**Ashburton Salt Project  
Groundwater Modelling Independent Review  
June 2021**

**Executive Summary**

CyMod Systems was appointed to undertake an independent review of the numerical groundwater model, which was constructed and calibrated to assess the potential impacts of the proposed K+S Ashburton Salt Project on environmental receptors.

**Figure 4-1: Soil Classification showing Relationship between Particle Size and Specific Yield (Johnson, 1968)**

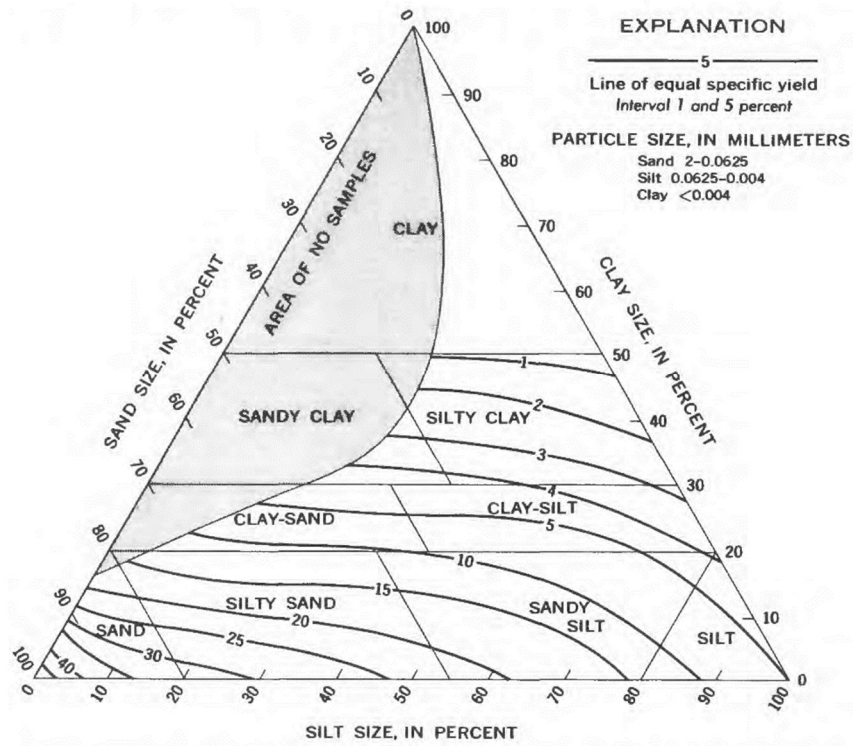
A brief review of estimates of specific yield from particle size distribution of field samples is shown in Table 4-2. Estimates of specific yield have been taken from Figure 4-1 based on silt/clay content measured in soil samples. The data suggests that a specific yield of 0.05 and an effective porosity of 0.10 as suggested in the conceptual model for the 1A/B formation are reasonable but conservative. The limited data for the 2A and 2B formations suggests a low specific yield may also be conservative.

The effective porosity of 0.10 as used in the 1A/B unit is consistent with conservative estimates of these properties, as indicated in the report. The low effective porosity will increase the impact of seepage and EVT, in terms of rate of change in salinity and groundwater level changes.

It is also noted that test pumping of BH7 TB, BH10 TB measured responses primarily in the 2A/B formation and indicated a specific yield of 0.05. It is likely the 1A/B formation will have higher specific yield, given higher sand content.

**Figure 1: Mangrove Monitoring - Pilbara, 1990**

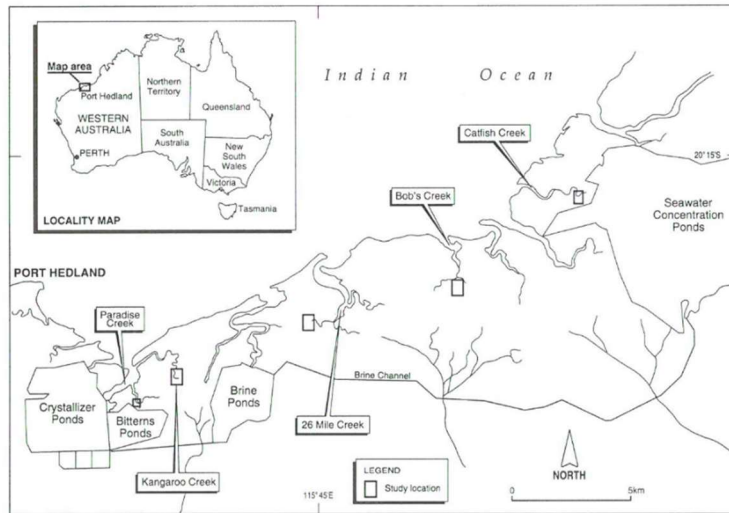
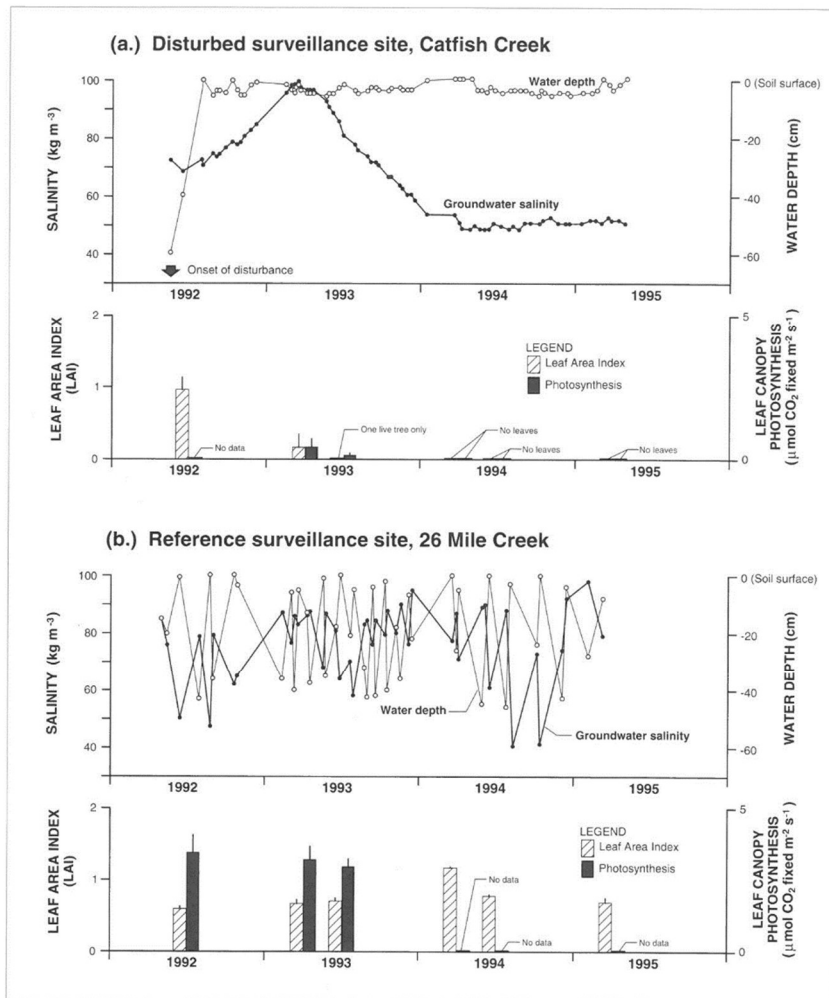
A secondary effect on pond seepage is also caused by the lack of vertical resolution in the model. The mixing of pond seepage into the relatively thick layer 1 of the model results in much less dilution than would occur in practice. In practice, pond water salinity in ponds 1, 2 and 3 is much less than that of shallow groundwater, and hence, any seepage will tend to float on top of the denser insitu brine. This light low-salinity seepage will migrate through pond embankments and to a lesser extent displace the in-situ dense brine downstream. The net effect is that shallow groundwater in the vicinity of the salt ponds is likely to have similar salinities to that of pond water floating on denser in-situ brine. This buoyance effect is only effectively modelled using sufficient vertical resolution (i.e., layers) to simulate the vertical salinity gradient in the vicinity of the salt ponds.

The above effects were measured at a site downstream of a salt pond in the Pilbara (Figure 1, Catfish Creek), as shown in Figure 2 (Gordon *et al*, 1995). Note that mangroves did not recover, even though groundwater salinity declined to viable levels, but water levels remained elevated due to pond leakage (essentially water logging of the mangroves). Such water logging may or may not be an issue for mangroves at the Ashburton Salt Site given the different physical location and distance from the ponds compared with the example provided. However, this requires further project specific investigation via revised modelling.
